Subject: Cable Tray Support Review Questions
Comanche Peak Steam Electric Station
Independent Assessment Program - Phase 4
Job No. 84056

1. Detail SP-6; Support Numbers 360 and 3011

2. Detail SP-8; Support Number 455

3. Regular Case L-A₄; Support Number 481

DRAWING 2A

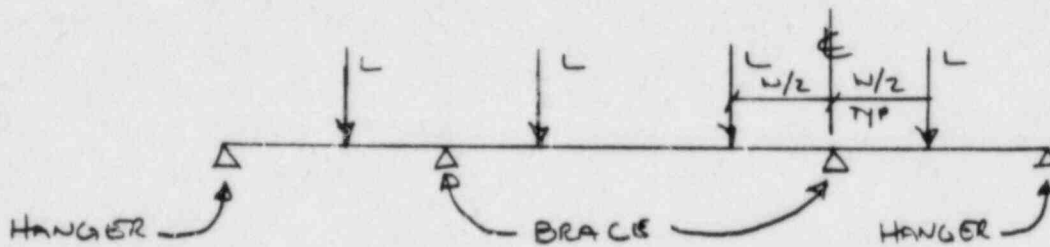
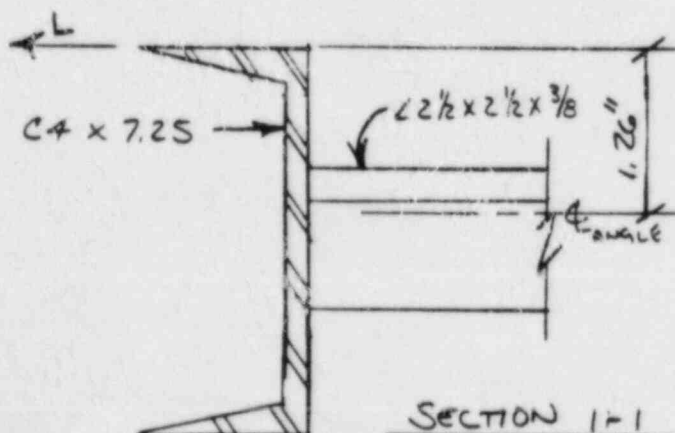
The longitudinal loads were considered to be carried through the beam members to a brace which was attached to the concrete wall. The purpose of the brace was to eliminate weak-axis bending in the beam member. It is Cygna's opinion that weak axis bending as well as torsion of the beam will occur due to the imposition of the longitudinal loads. The attached drawing of the beam and brace as well as an analytical representation of the beam shows the actual eccentricities of the loads.

Support 455 was reviewed by Cygna and checked in the field during the walkdowns. The installed support does not contain braces which restrain lateral movement. The braces for the longitudinal loads were moved such that they are located at the centerlines of the hanger members. At this location they provide no load transfer of the longitudinal loads to the concrete through the beam members. Thus, weak-axis bending and torsion must be resisted by the beam members alone.

- (a) The capability of generic SP-8 supports to resist the effects due to lateral loads;
- (b) The capability of the beam members to resist weak-axis bending and torsional moments;
- (c) The use of a member which has a slenderness ratio in opposed violation of AISC Code section 1.8.4;
- (d) The capability of the brace members to resist eccentric loads;
- (e) The suitability of the Detail SP-3 hanger connections for use on SP-8 supports;
- (f) The capability of the anchor bolts used in the brace design to resist the design loads;
- (g) The capability of Hilti expansion anchors to resist design loads which are eccentrically applied to the base connection;
- (h) The acceptability of the allowed eccentricity for the brace connection; and
- (i) The capability of support 455 to resist the applied loads including the effects noted above.

DRAWING 3A

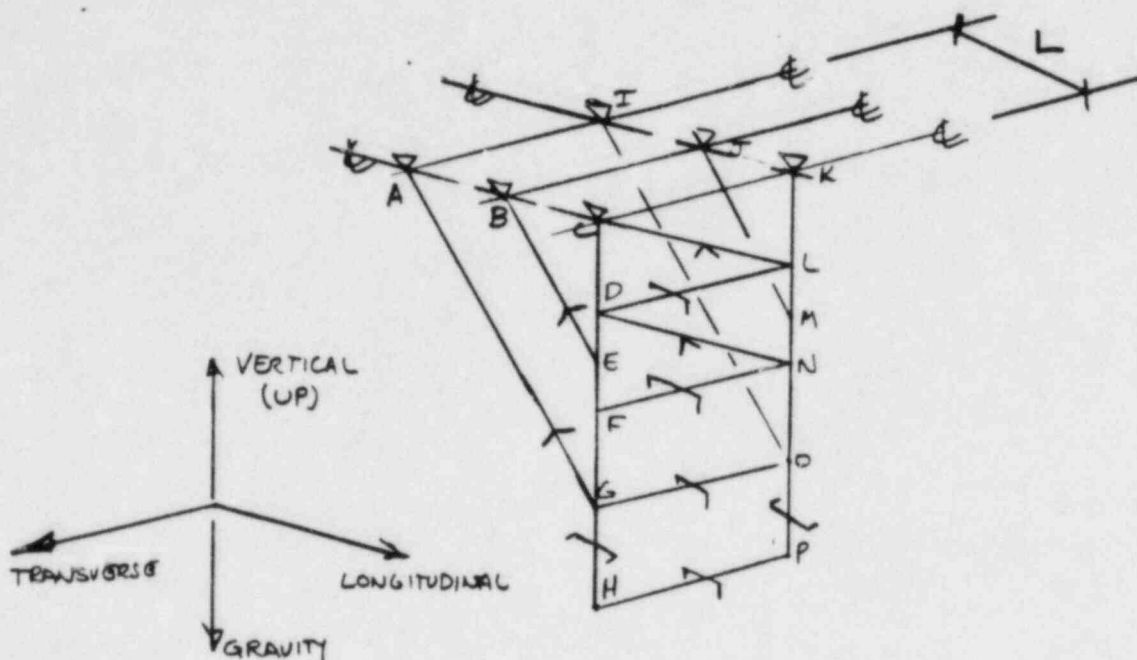
A representation of a typical Regular Case L-A₄ support is shown on the attached sheet 3A. The analytical model of the support consisted of members CDEFGH, BE and AG. Boundary conditions were assumed as pinned ends for joints A, B, C, E and G. A vertical load was applied in the gravitational direction at node H. A longitudinal load was also applied at node H. Transverse loads were not considered in the analysis.

It is Cygna's opinion that the analytical model as described above is inadequate to correctly predict the behavior of the support under the applied loadings. By considering only a planar frame rather than a space frame, several important loading effects were neglected. The primary effect is the bending moment induced into the beam member HP by vertical loads. These could not be predicted because beam member BE was not modeled and the vertical and longitudinal loads were applied at node B. Reference 3 shows the beam-hanger joints as moment resisting connections. Therefore, vertical and longitudinal loadings within the span of the beam will induce flexural and torsional moments into the hanger members CDEFGH and KLMNOP.

Brace members CL and DN were not designed because the support was modeled as a planar structure. Brace members AG, BE, IO and JM were not designed for the eccentric application of loads. Such eccentric loadings will induce moments into the angle sections that must be considered in the design.

- (a) The capability of Regular Case L-A₄ cable tray supports to resist the design loads. Please discuss the effects due to transverse loads as well as those local effects due to vertical, transverse and longitudinal loadings;
- (b) The capability of the bracing members to resist eccentrically applied loadings;
- (c) The suitability of using a moment arm to individual bolts rather than the centerline of the base attachment to which they connected; and
- (d) The capability of the anchor bolts to resist the design loads.

DRAWING 3B

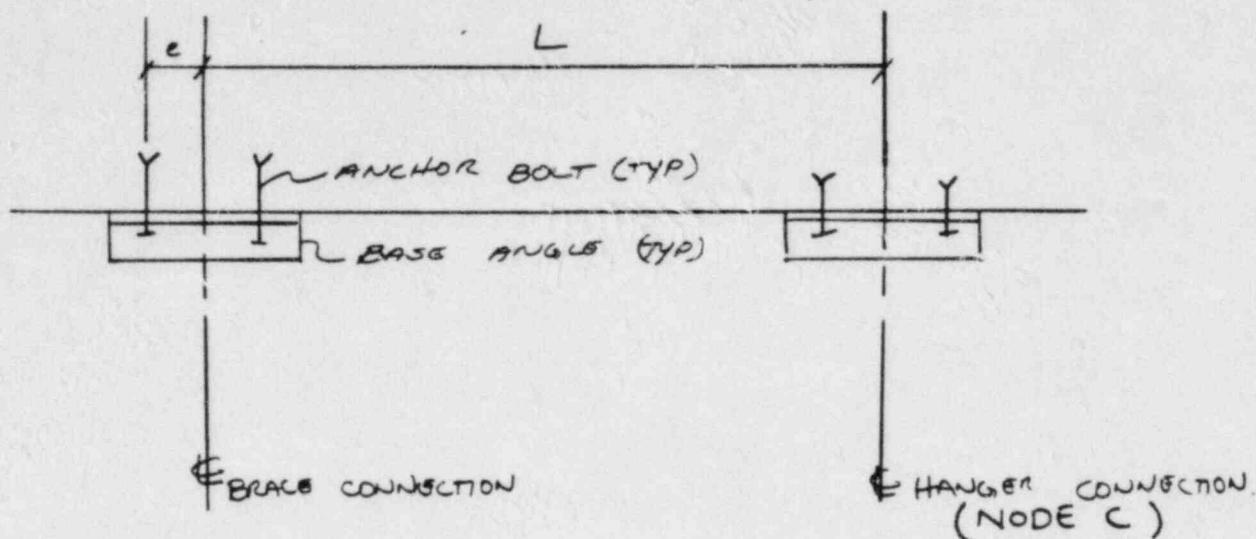
The original design calculations (reference 2) were not consistent in the application of loads for checking anchor bolts. The anchor bolts were checked for the shear and tension forces due to longitudinal loads only. The effects from both vertical and transverse loads were ignored. In checking the anchor bolts, moments of the applied longitudinal load were taken about node C and a resisting bolt tension was calculated at node A. The moment arm to point A was calculated as $L + e$ rather than L as shown in the attached sketch 3B. The use of the larger moment arm results in a bolt tension 4% smaller than actual.

DRAWING 4A

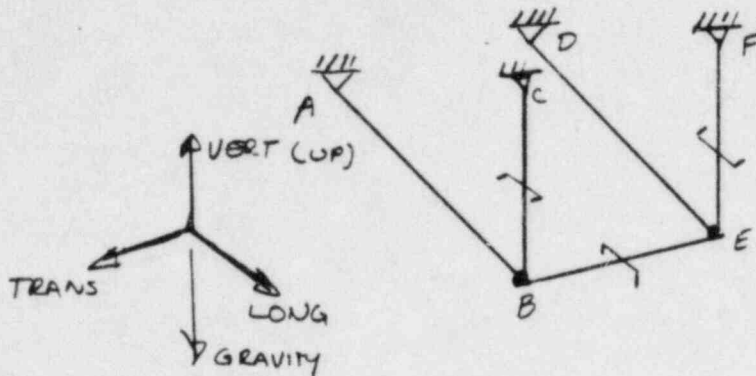
A representation of a typical Regular Case L-A₁ support is shown on the attached sheet. The analytical model of the support consisted of only members AB and BC. Boundary conditions were assumed as pinned ends for joints A, B and C. A vertical load was applied in the gravitational direction at node B. A longitudinal load was also applied at node B. Transverse loads were not considered in the analysis.

It is Cygna's opinion that the analytical model, as described above, is inadequate to correctly predict the behavior of the support under the applied loadings. By considering only a planar frame rather than a space frame, several important loading effects were neglected. In particular, the effects of the vertical and longitudinal bending moments induced into the beam member BE were not considered. These moments could not be predicted because beam member BE was not modeled and the vertical and longitudinal loads were applied at node B. Reference 3 shows the beam-hanger joints as moment resisting connections. Therefore, vertical and longitudinal loadings within the span of the beam BE will induce flexural and torsional moments into the hanger members BC and EF.

Eccentric loadings of the brace member were not considered in the analysis and design of the frame. Such eccentric loadings will induce moments into the angle section that should be considered in the design.

- (a) The capability of Regular Case L-A₁ cable tray supports to resist the design loads. Please discuss the effects due to transverse loads as well as those local effects due to vertical, transverse and longitudinal loadings;
- (b) The capability of the bracing members to resist eccentrically applied loads; and
- (c) The capability of the anchor bolts to resist the design loads.
